REGULAR PLANNING COMMISSION MEETING

OAK PARK, MICHIGAN
FEBRUARY 2, 2026
6:00 PM

1. Site Plan Review, El Car Wash, 24850 Greenfield Rd.

SUBJECT: Site Plan Review – El Car Wash - Oak Park, 24850 Greenfield Rd.

LIGHTING PLAN

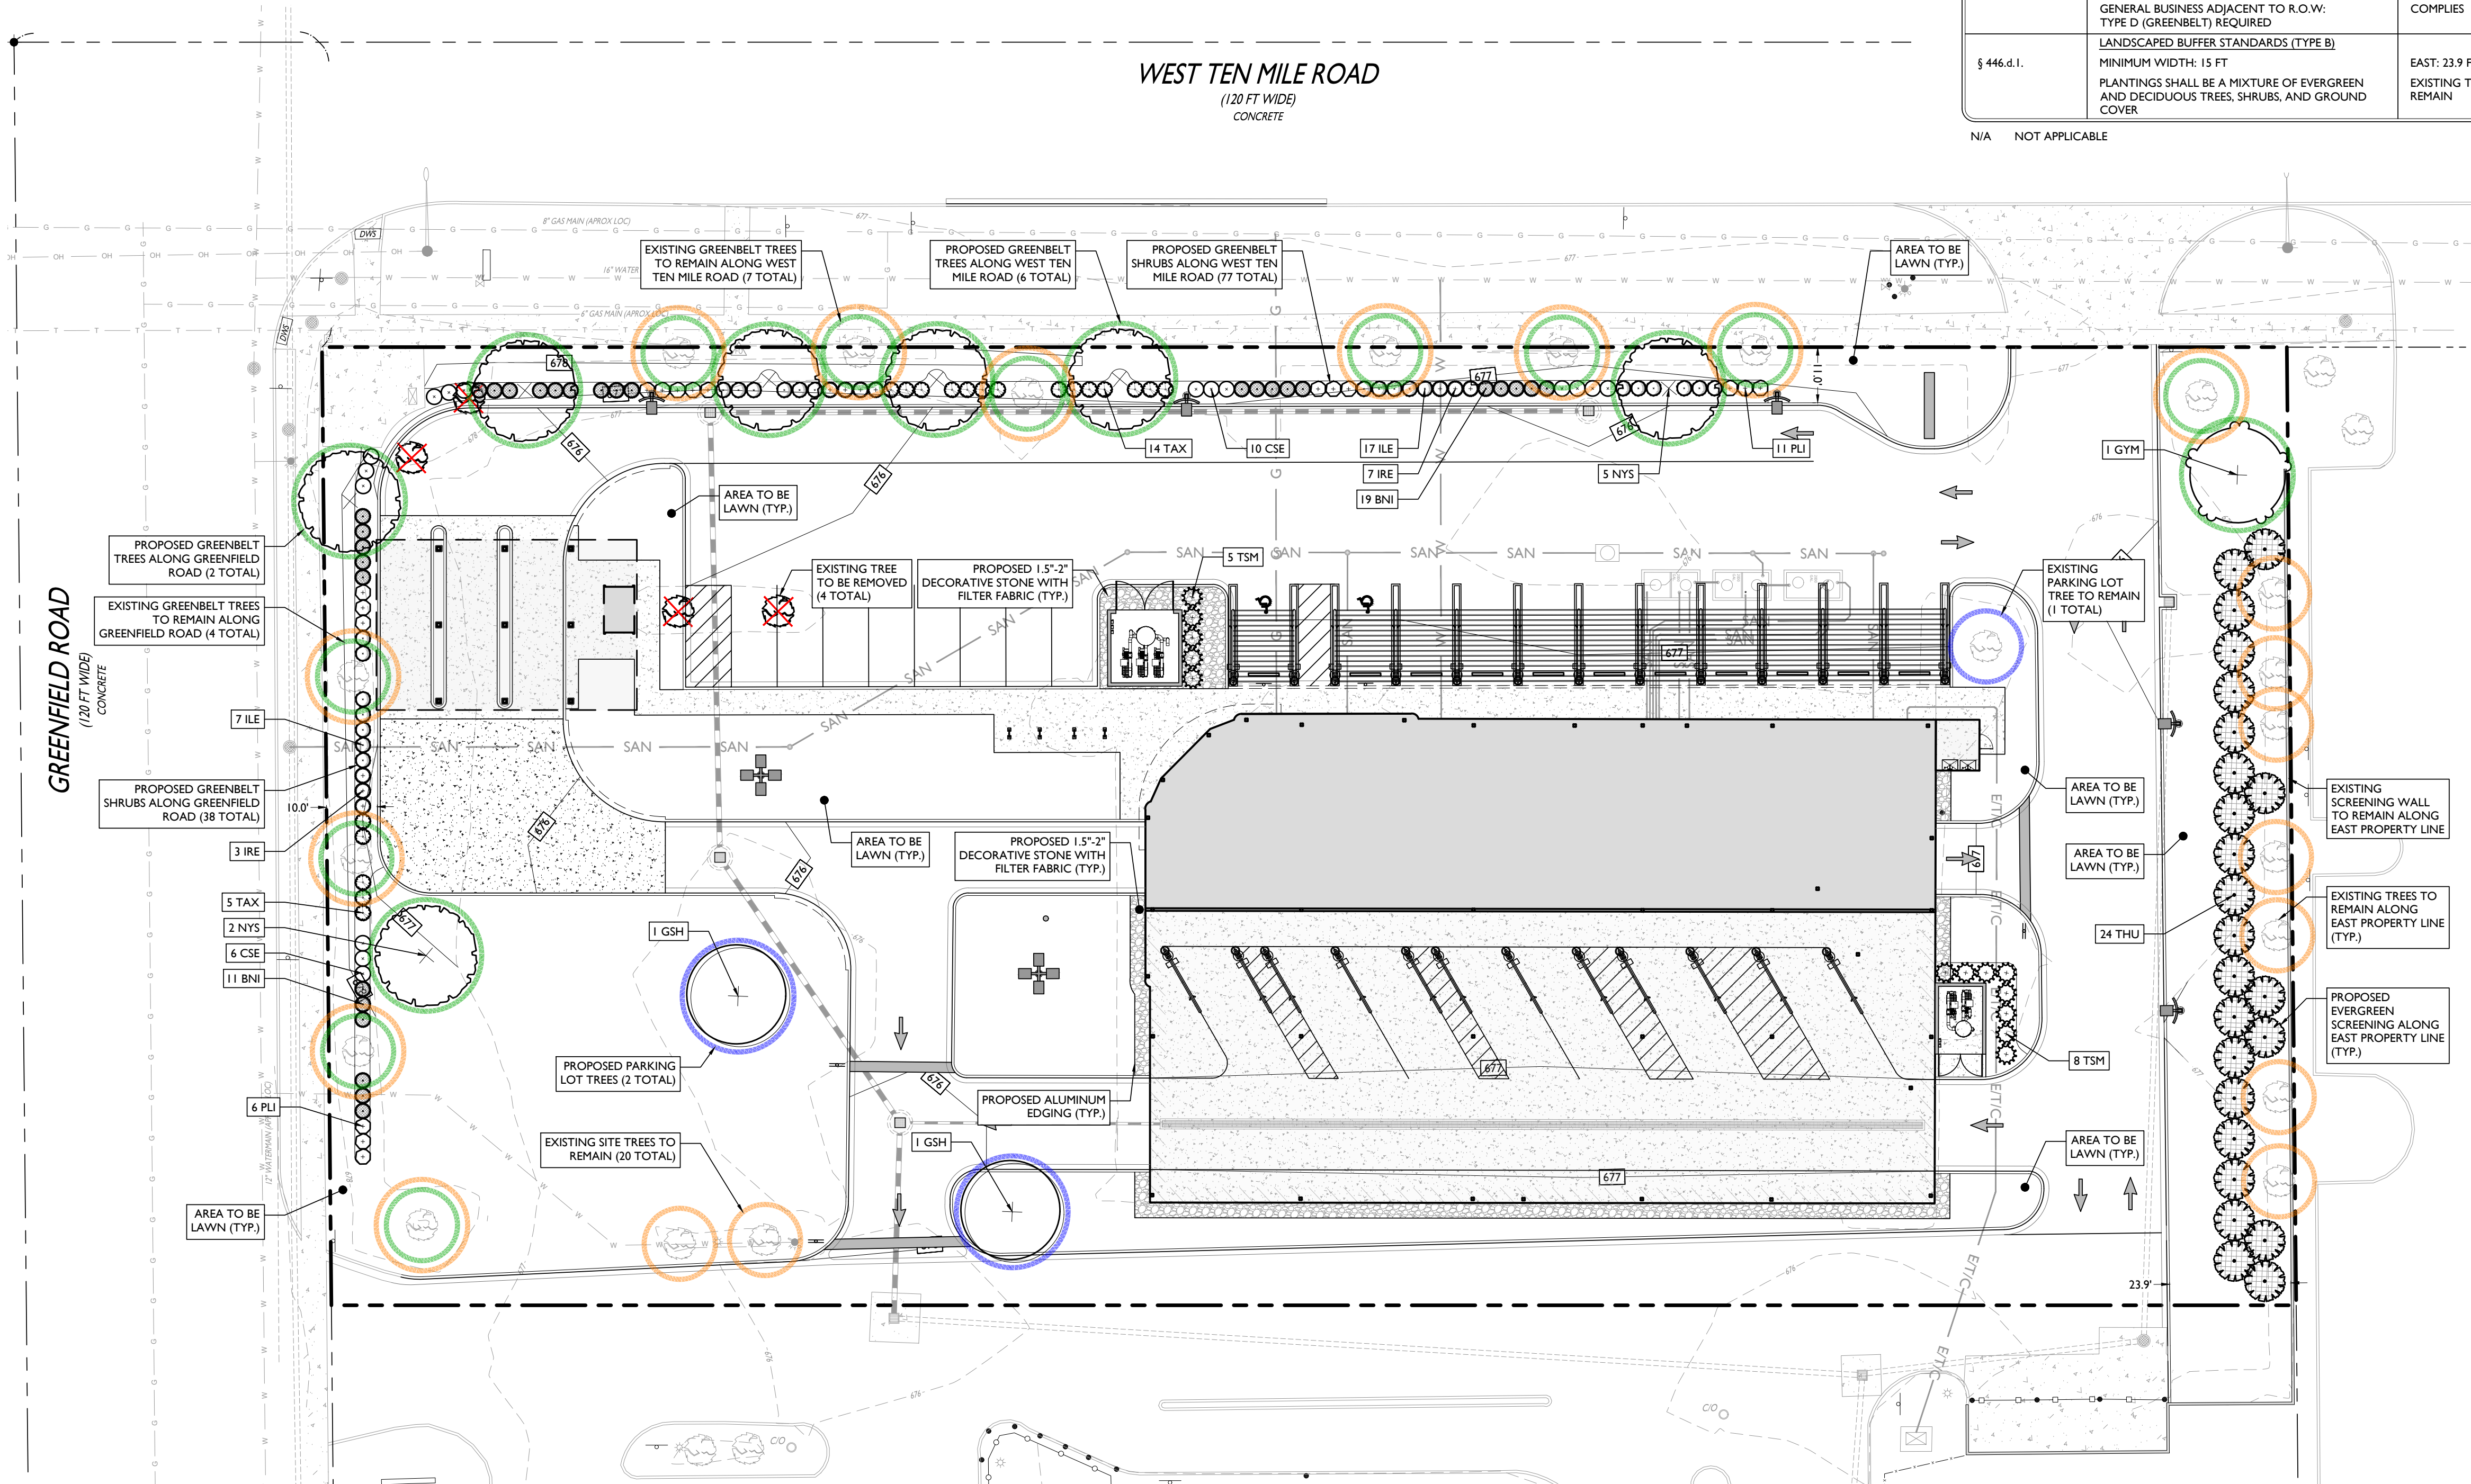
Lighting. The light plan depicts an average intensity of 0.8 footcandles along property lines consistent with the zoning ordinance. Any existing or proposed exterior light fixtures should be shielded and downward cast to eliminate the possibility of nuisance to the adjoining properties. The intensity of light within a site shall not exceed one (1)

PROPOSED WEST ELEVATION
SCALE : 1/4"=1'-0"

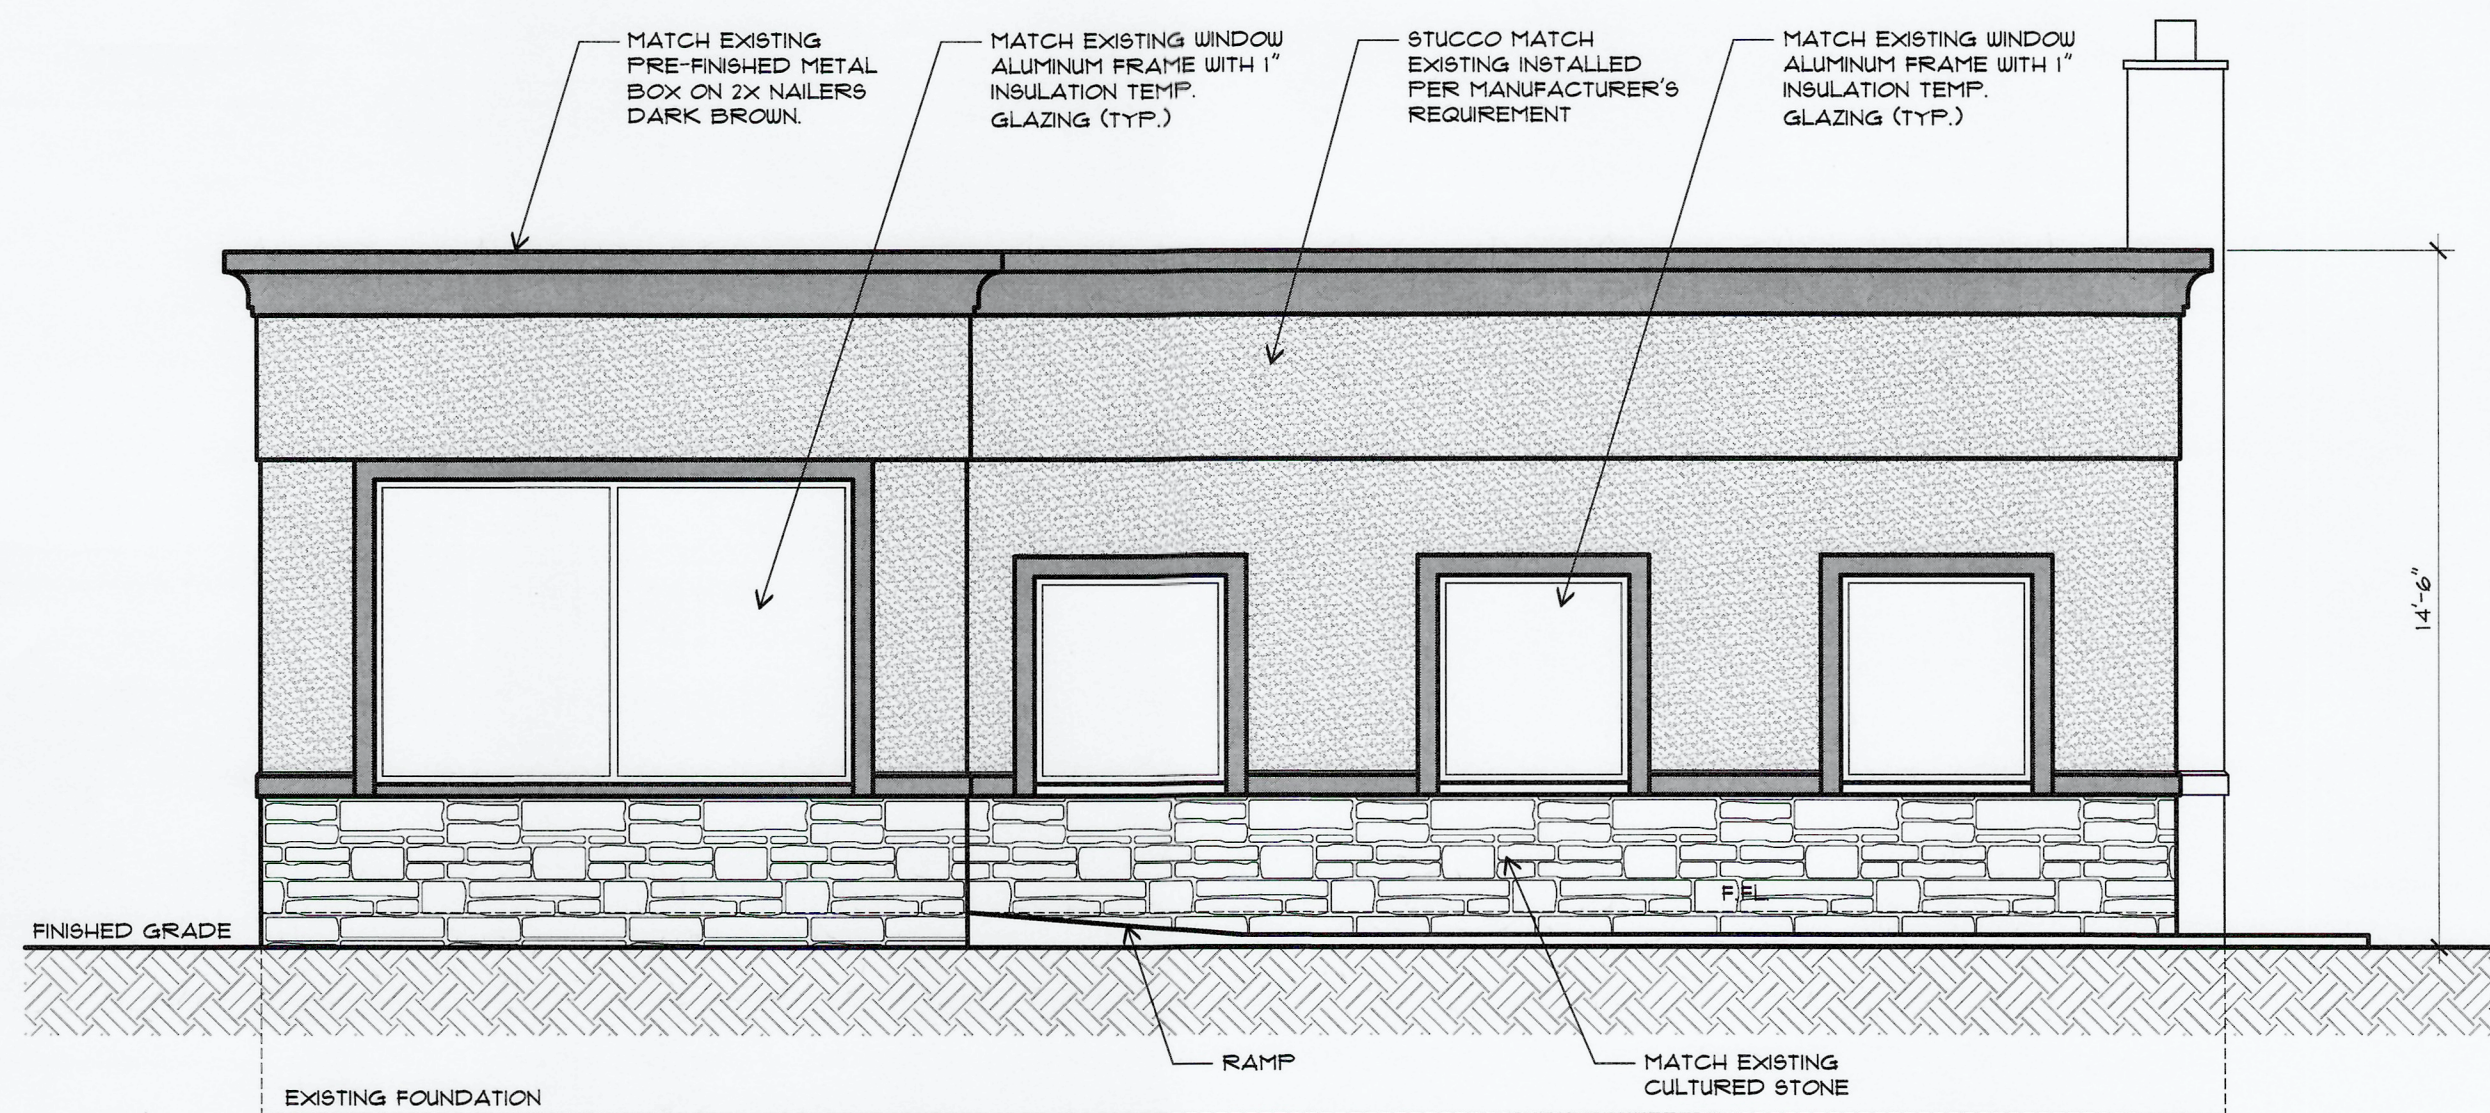
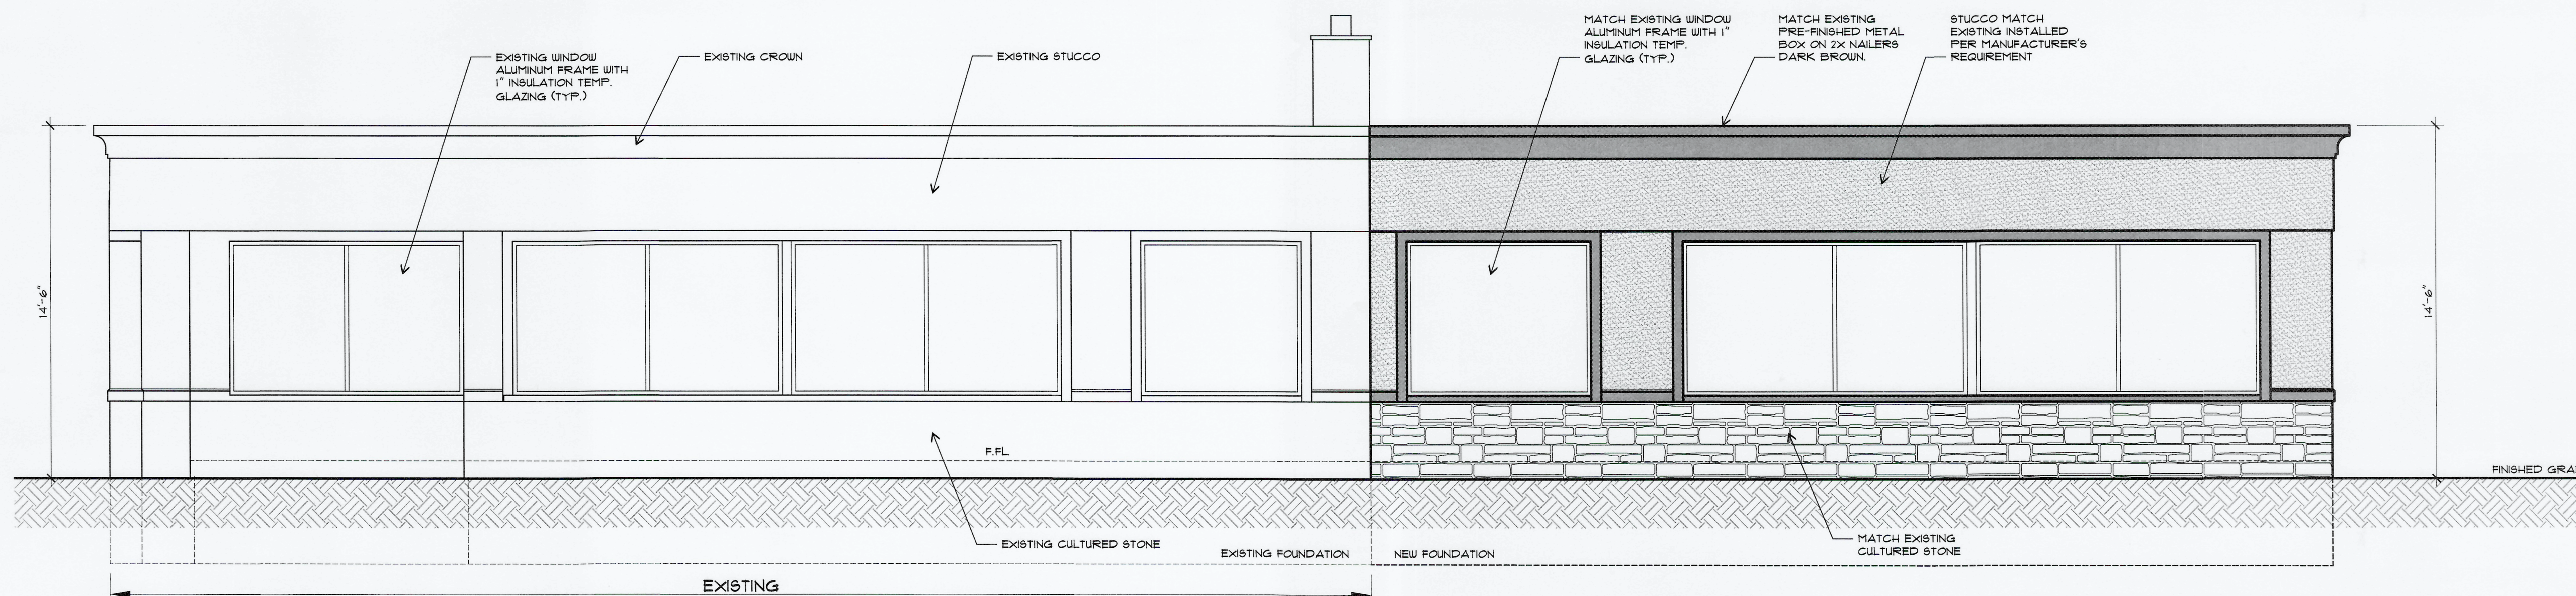
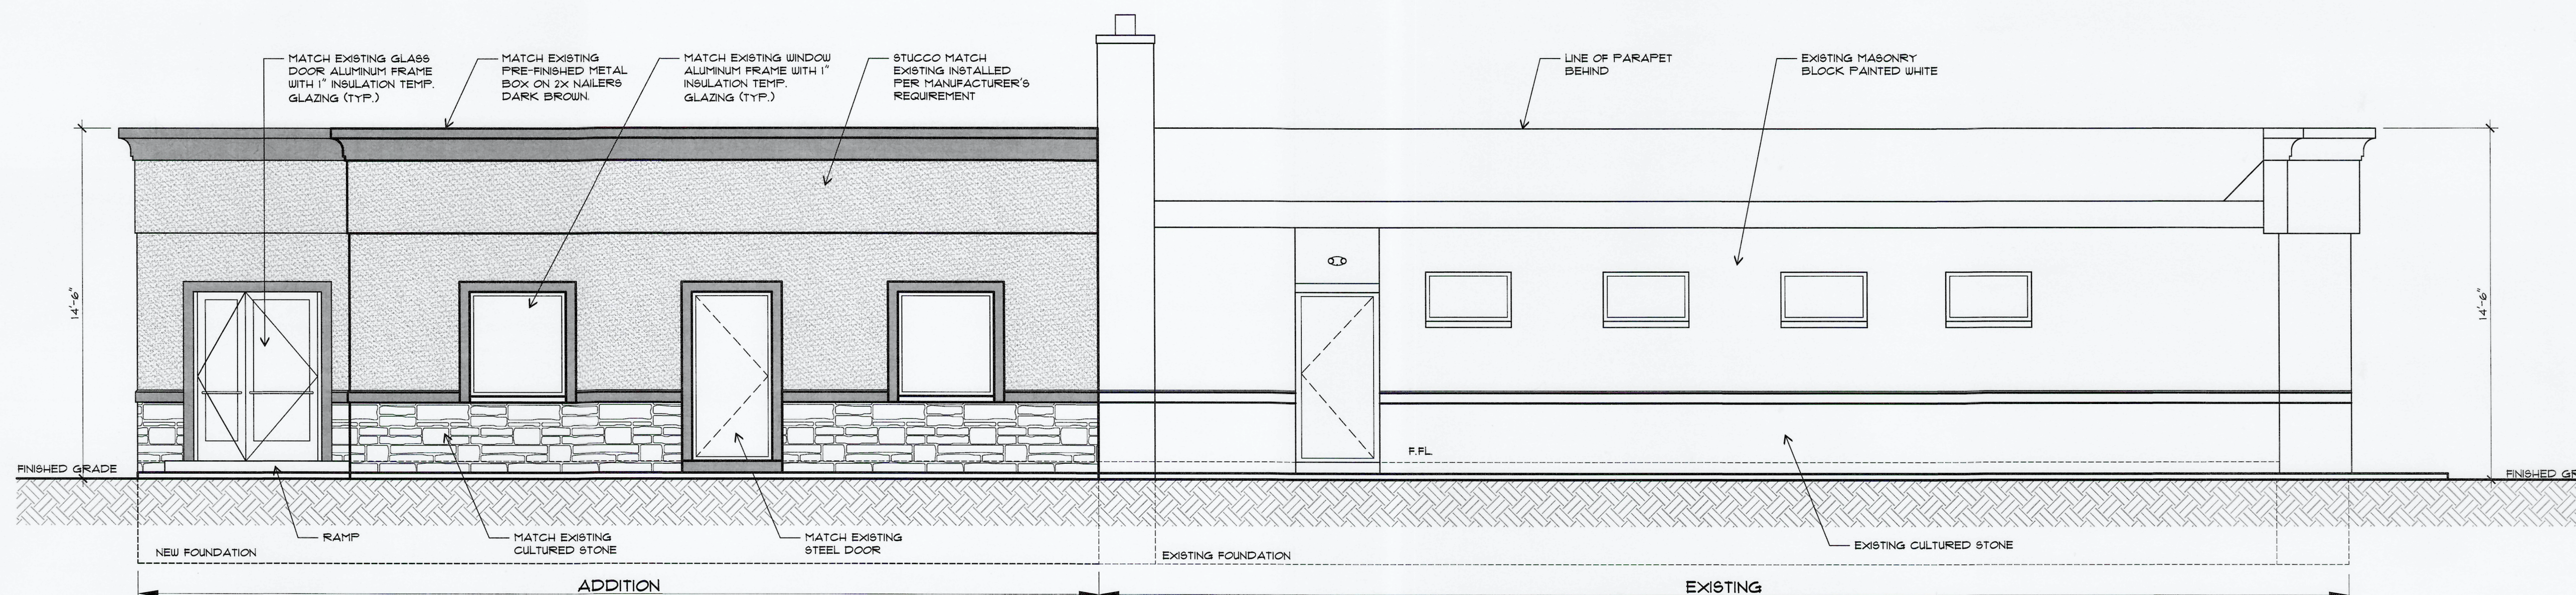
This site plan depicts modifications to the existing principal building. The existing building is constructed of brick, split-face CMW, and an aluminum frame with insulated glass. The proposed elevation design includes EIFS and high intensity colors, which are not permitted by the Zoning Ordinance. The applicant shall work with the Economic Development and Planning staff to revise the proposed building materials and color palette to ensure compliance with the Zoning Ordinance. In addition, the applicant shall provide the fenestration percentage for the primary facade, noting that the reflective glazing shall not be counted toward the required fenestration for commercial buildings.

2. Self-contained, covered waste receptacles shall be provided at each proposed vacuum station to provide convenient disposal of customer refuse.
3. The applicant shall work with the Economic Development and Planning staff to revise the proposed building materials and color palette to ensure compliance with the Zoning Ordinance. In addition, the applicant shall provide the fenestration percentage for the primary facade, noting that the reflective glazing shall not be counted toward the required fenestration for commercial buildings.
